## **Response to submissions – Minto Resource Recovery Facility (SSD 7462)**

This letter responds to the items raised in the *Bingo Resource Recovery Facility, 13 Pembury Road, Minto (SSD 7462) Request for Response to Submissions*, issued on 22 August 2017 and 14 February 2018.

**RE: 13 PEMBURY ROAD, MINTO  
SWEEP PATH ANALYSIS – RESPONSE TO DEPARTMENT OF PLANNING**

EXISTING GROUND  
FLOOR PLAN

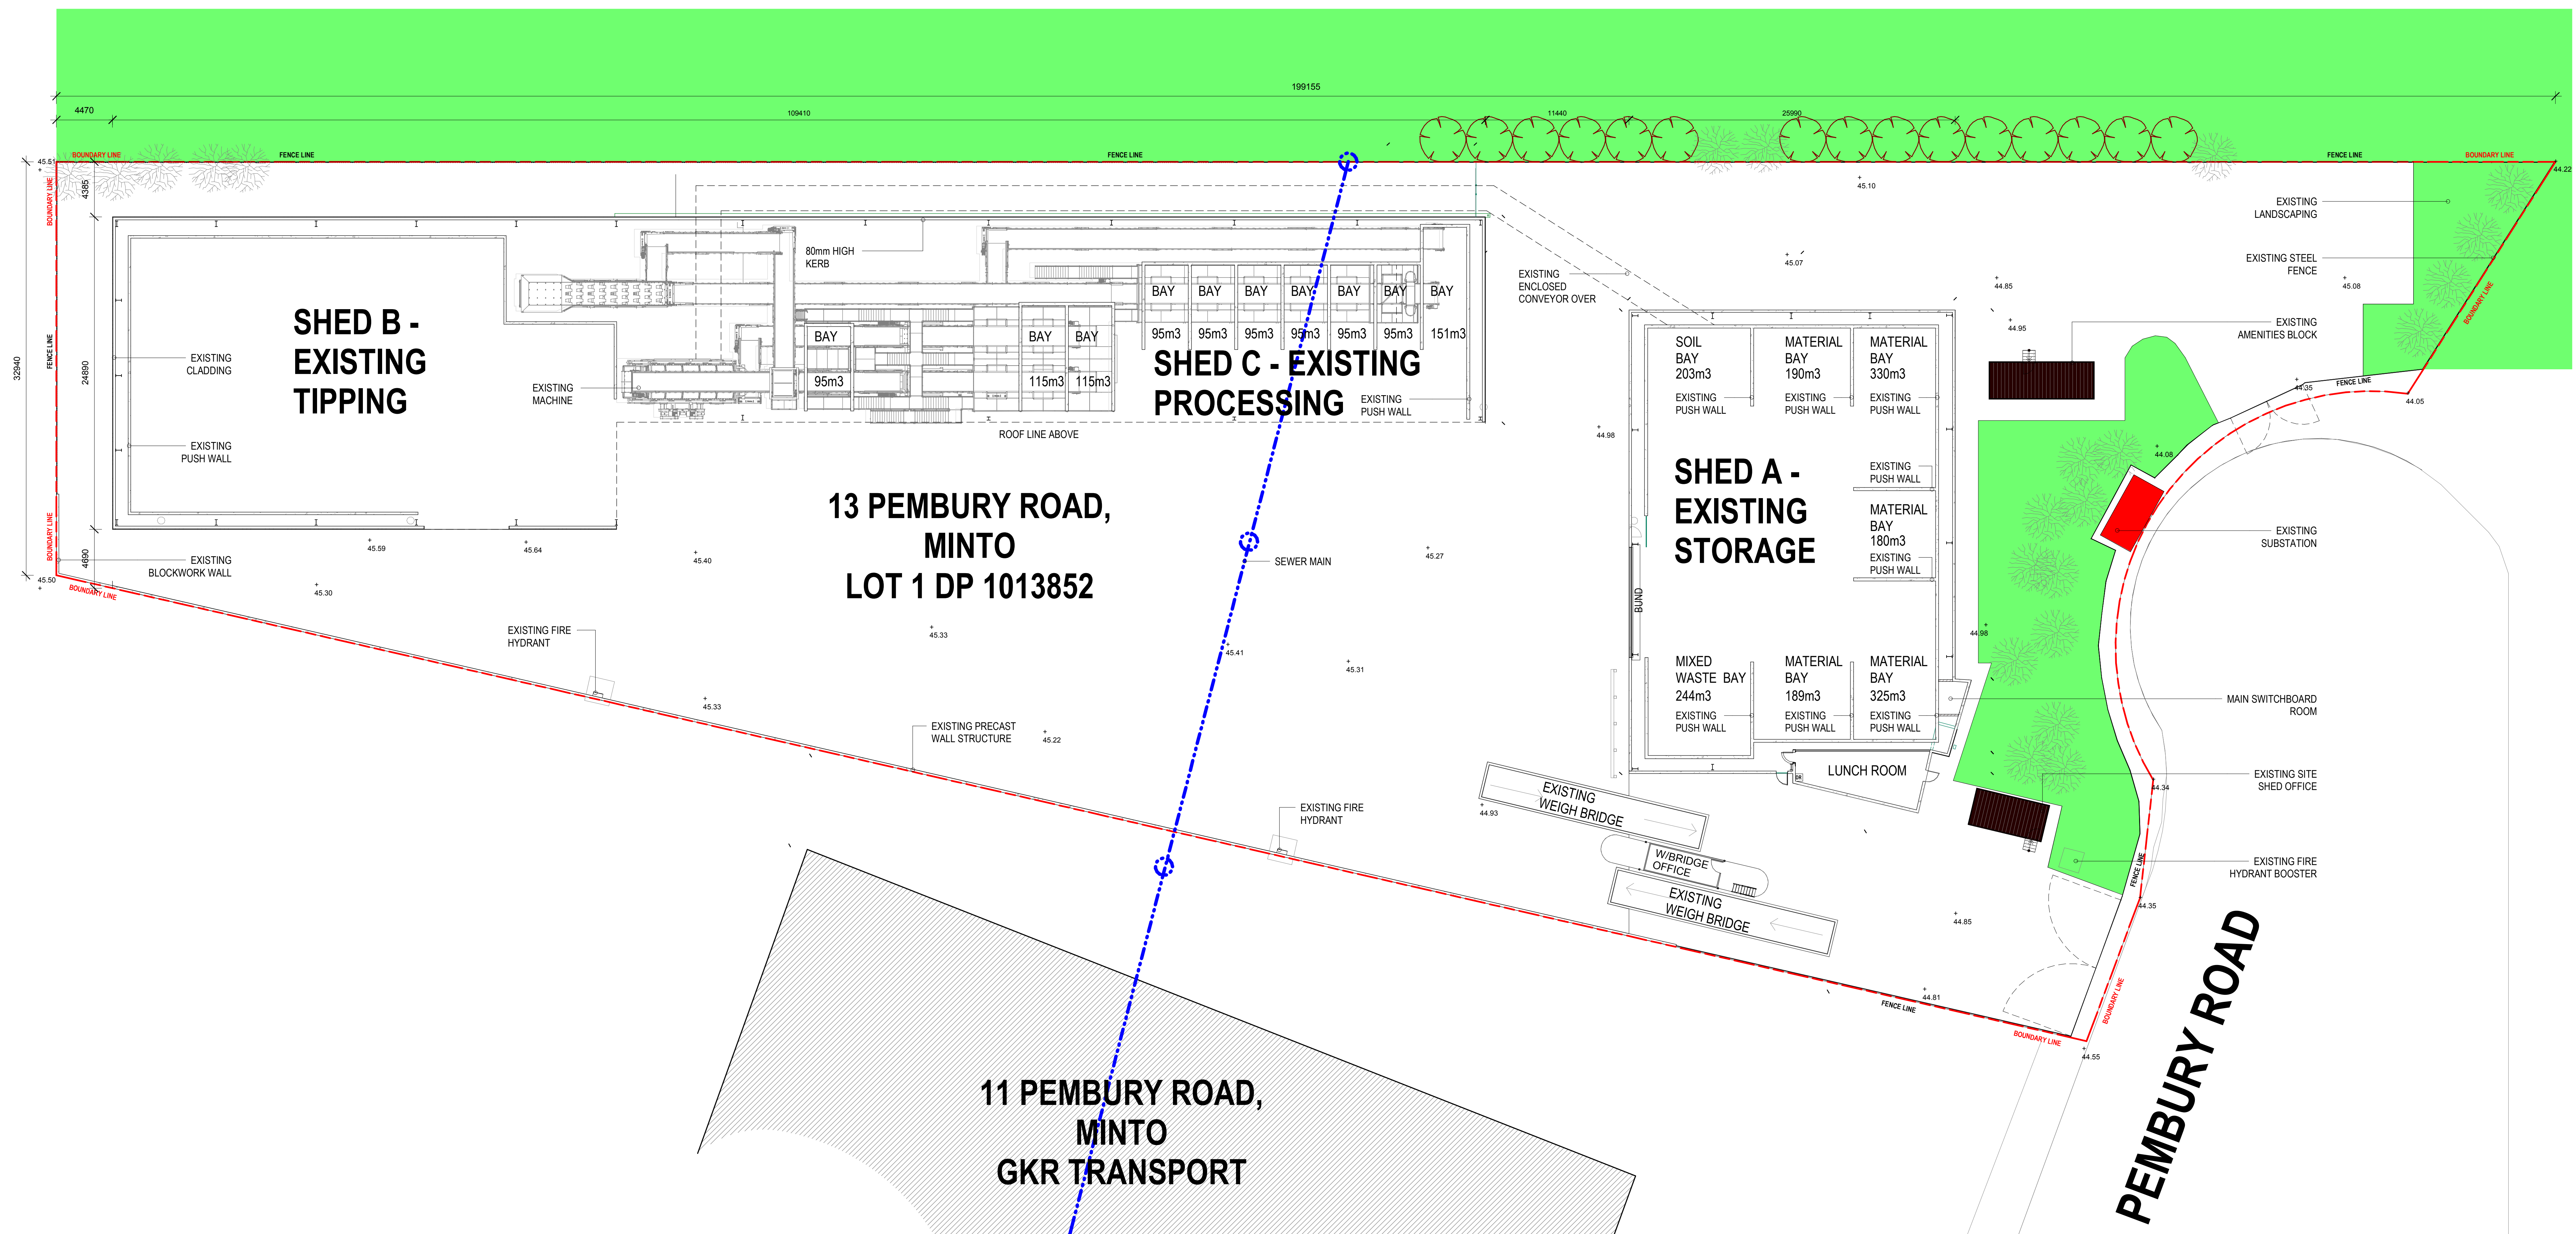
Submission	Response / comment	Reference
provisions for a large isolated building.		
Provide floor plans and elevation plans for all existing structures on site.	Plans showing the layout for all existing structures on site have been provided in Attachment C of this letter.	Appendix C of this letter
